Volvo Chassis - Transmission Harness Wrap Failure Causing open- or short-circuits and datalink fault codes

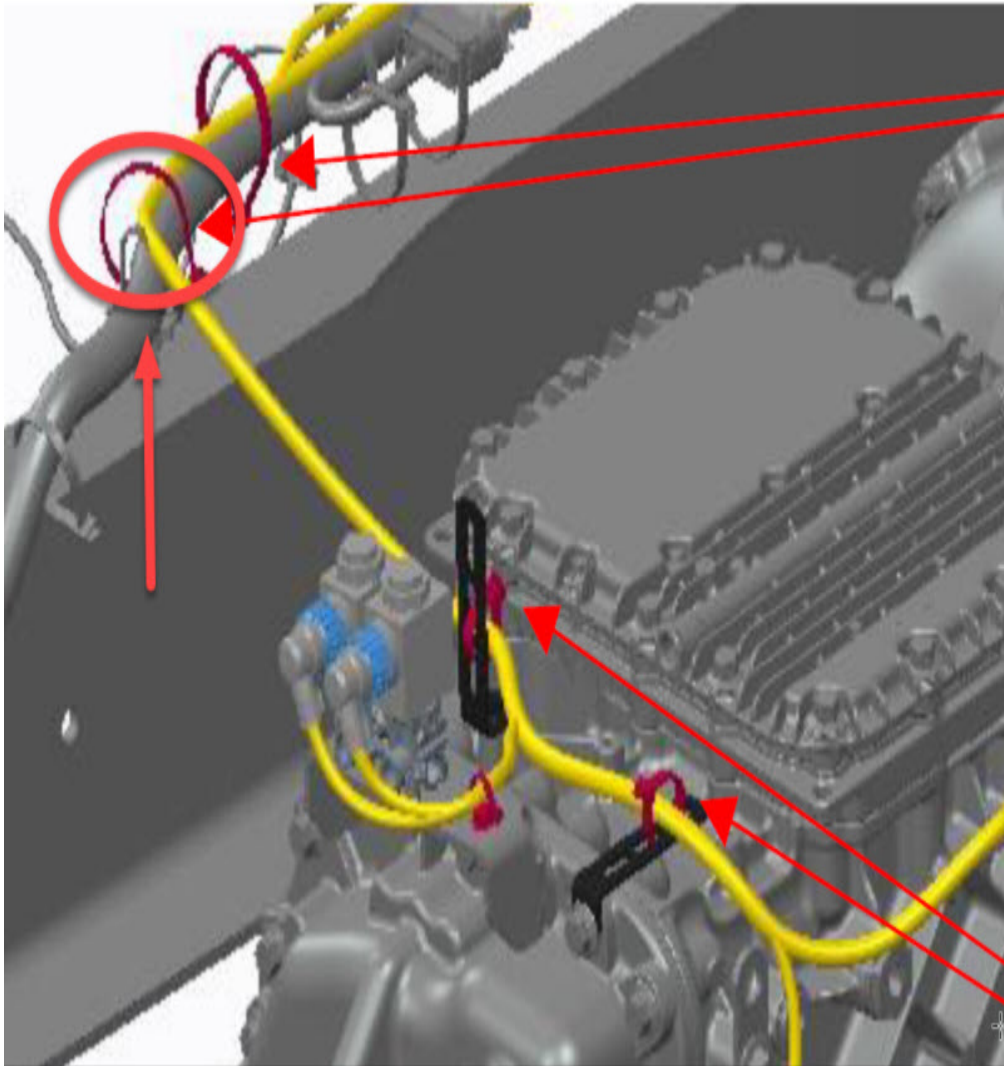
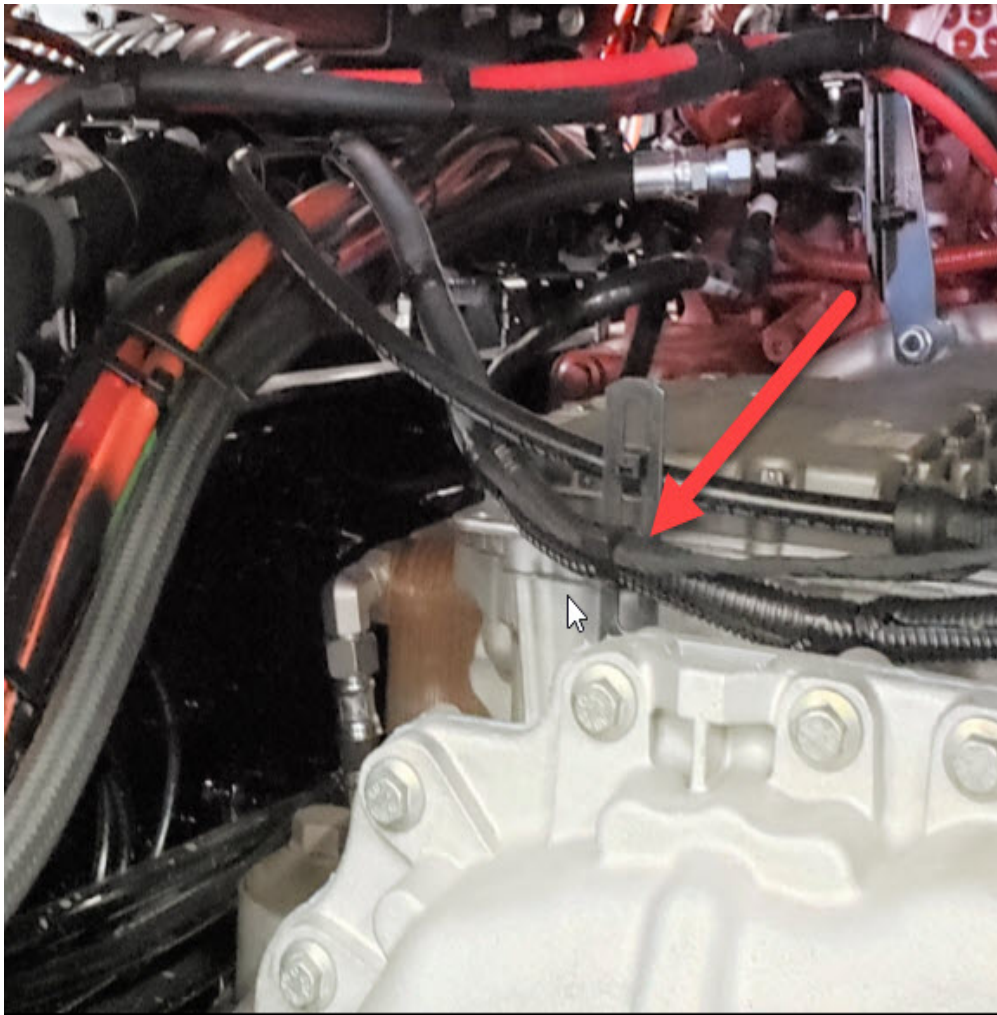
Some Volvo trucks, built April 25, 2016 - September 25, 2020, with AMT-F iShift transmissions were built with transmission harnesses that used split convoluted tubing. Split convoluted tubing can damage wiring insulation which can lead to open- or short-circuits and datalink fault codes. Updated transmission harnesses are available that use woven cloth tape and heavy duty wrap to protect the wiring from damage. See illustrations below.

Updated Transmission Harness Part Number	
Without crawler gears	23917360
With crawler gears	23917358
